MEMO

TO:Olivia Allen, Helen CrosbyFROM:Roy van BallegooyenSUBJECT: Final review of the SINTEF Drilling Discharge Modelling StudyDATE:September 15, 2023

I have undertaken a final review of the view of the SINTEF Report:

Figure 1: An example of a plot presenting the percentage of time where there exists a significant risk associated with drilling discharges (Source: HES, 2022).

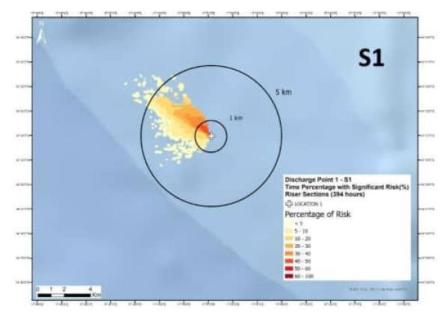
Initially, only the instantaneous plot of the risk in the water column at the time of maximum EIF was reported. This does not provide a conservative assessment of the spatial area of impact, that could occur at any time during the drill cutting disposal simulations. Accordingly, it was requested that plots be presented of the maximum cumulative risk in the water column throughout the drilling discharge simulations. These plots, however, are a very conservative estimate of impact as the spatial risk indicated in such plots include all areas risk even if of very short duration (*e.g.*, minutes to hours).

The inclusion of these plots ensured consistency with the risk levels reported in the earlier Drilling Discharge modelling studies (HES, 2020a, 2020b). More recent Drilling Discharge modelling studies (HES,2022) have provided a more nuanced way of presenting such results, namely spatial plots of the percentage of time a location is at significant risk during the model simulations. While this provides an integrated view of the extent and duration of impacts, <u>the SINTEF reporting provide a more conservative view of impacts with additional time series</u> that provide insight as to the limited duration of the impacts. This approach is consistent with the earlier Drilling Discharge modelling reports (HES 20230a, 2020b) that.
